EVALUATION OF PUL-E-KHUMRI I & PUL-E-KHUMRI II  
MINI-HYDROELECTRIC POWER PLANTS  
CITY OF PUL-E-KHUMRI,  
NORTHERN AFGHANISTAN

**Re: TETRA TECH FINAL REPORT  
EVALUATION OF PUL-E-KHUMRI I & PUL-E-KHUMRI II  
MINI-HYDROELECTRIC POWER PLANTS,  
CITY OF PUL-E-KHUMRI, NORTHERN AFGHANISTAN**

EVALUATION OF PUL-E-KHUMRI I &  
PUL-E-KHUMRI II MINI-HYDROELECTRIC  
POWER PLANTS  
CITY OF PUL-E-KHUMRI,  
NORTHERN AFGHANISTAN

FIGURE 3 – TYPICAL GHORī BRESHNA WATER CANAL PLAN

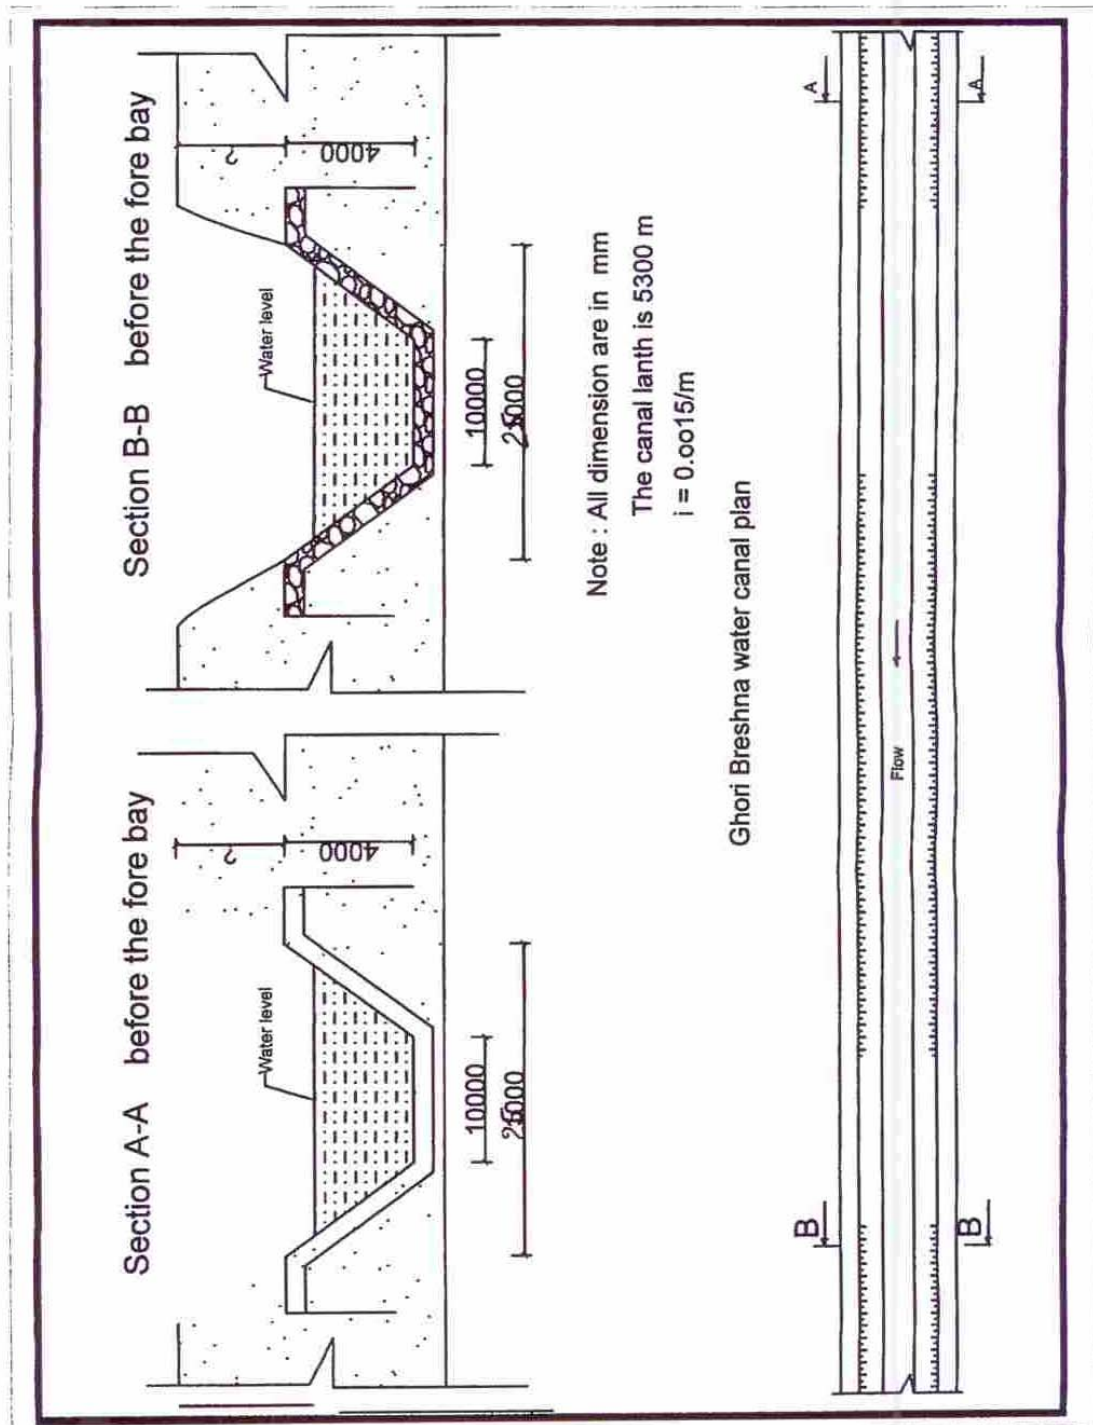
Based on the dimensions shown on Figure 3 for the Ghorī Breshna Water Canal Plan and the USACE reporting above, the existing carrying capacity of the existing power canal system is on the order of 39 m<sup>3</sup> per second, which is roughly 70 percent less than the total carrying capacity of the canal system of 144 m<sup>3</sup> per second without the deposited sediment.

Dredging the canal of the sediments (upwards of an estimated 300,000 cubic meters and more) is the only solution to achieve the former total carrying capacity of the canal needed for restoring the original power generating capacity of the existing dam facility. A selected dump site for the dredged sediments from the canal is reported to be located in the Kar Kar area (the grid for the general dump area is 42SVE7684) and is located approximately 20 to 25 km away from the City of Pul-e-Khumri.

**Trash Rake Screen Assemblies at Pul-e-Khumri I Hydroelectric Power Plant Facility (before the Baghlan River storm runoff event occurred).**

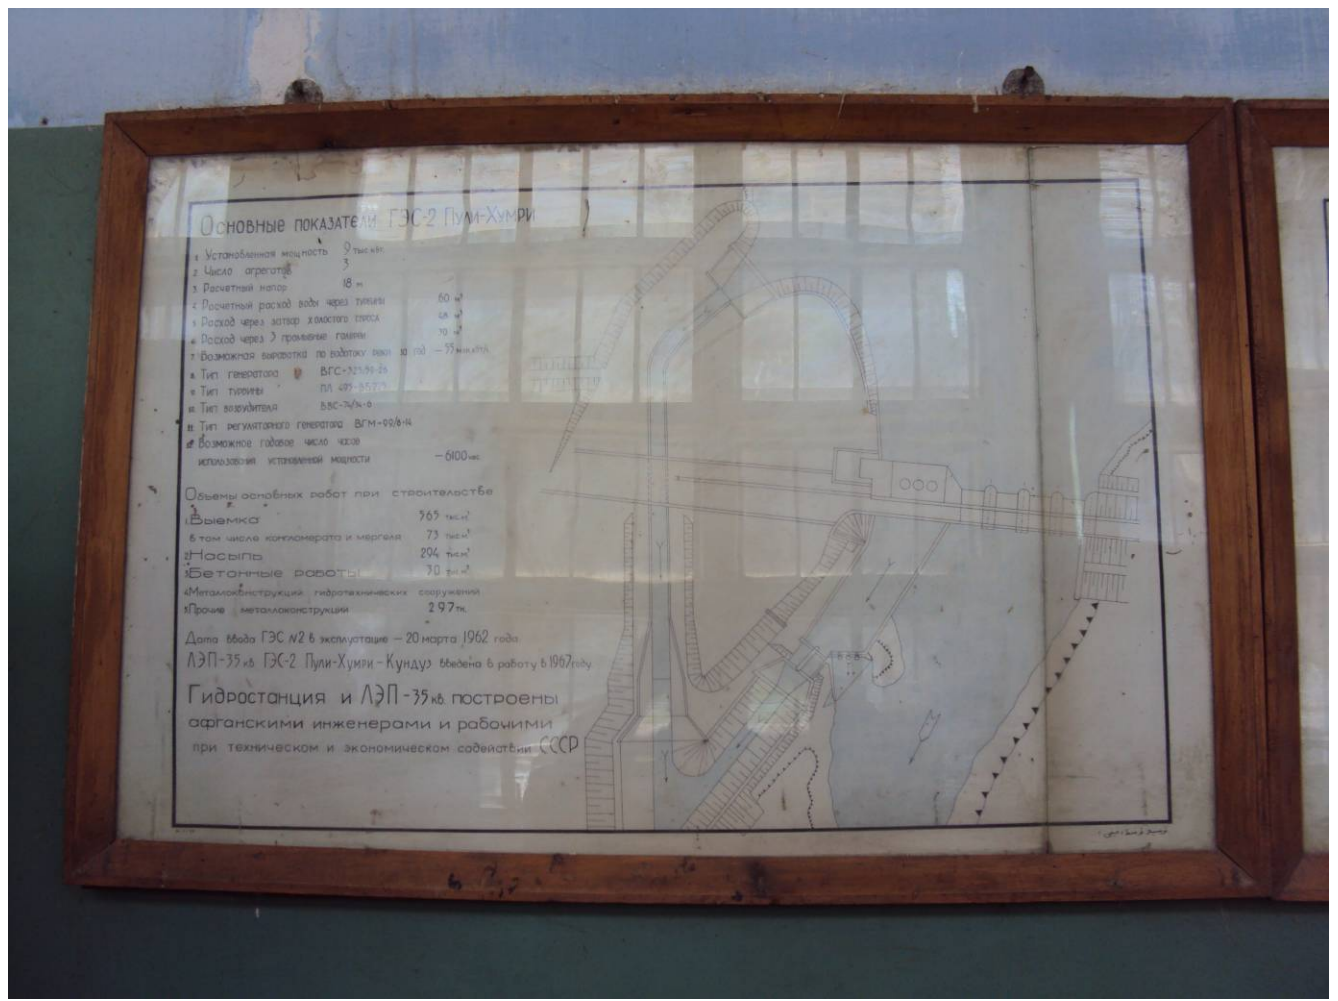
During Tetra Tech's two site visits to this facility, the trash racks and trash rake were noted as being operational and functional. The second site visit was made soon after heavy rainfall and minor flooding on the Baghlan River had occurred and it was observed that the equipment was capable of removing a significant amount of debris. To date however, the recabbling repair requirement noted in the USACE report has not been performed.
